SERVICE BULLETIN

TR-9000

#824

SUBJECT: TR-9000 CW, SSB TX INSTABILITY

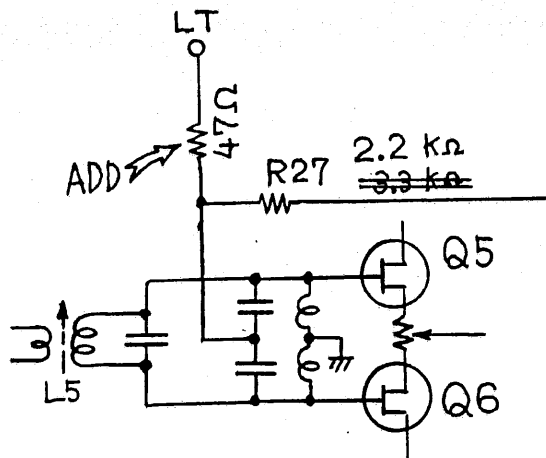
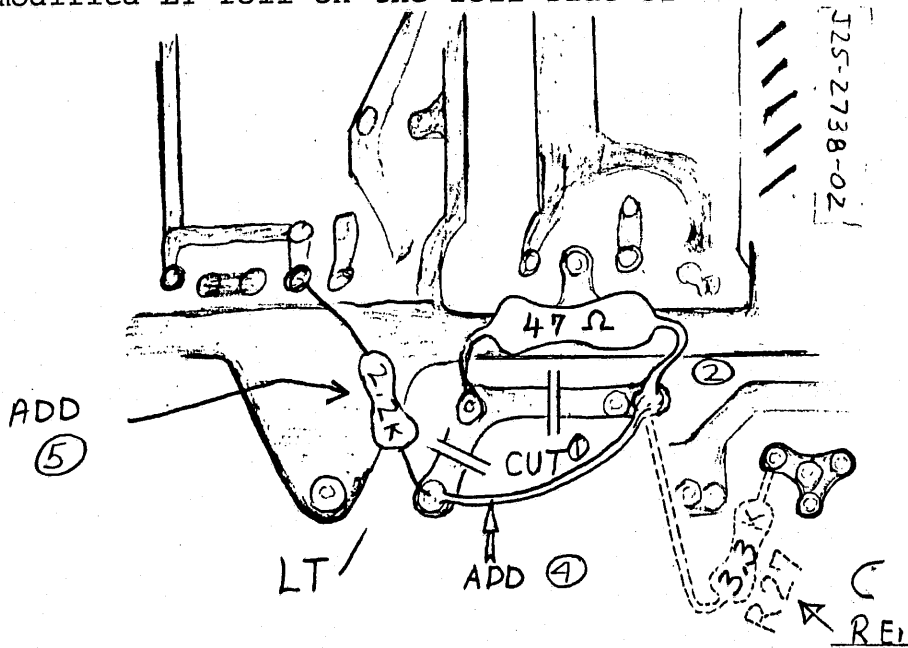
Complaints of FMing in SSB, or CW chirp may be eliminated by minor changes to the TX mixer circuit.

On the TX unit X56-1370-10, perform the following changes:

1. Cut the LT foil path.
2. Install a 47Ω resistor on the foil side of the PCB.
3. Remove R27, $3.3K\Omega$ and delete.
4. Jumper the cut foil.
5. Install a $2.2K\Omega$ resistor from Q12 collector to the modified LT foil on the foil side of the PCB.
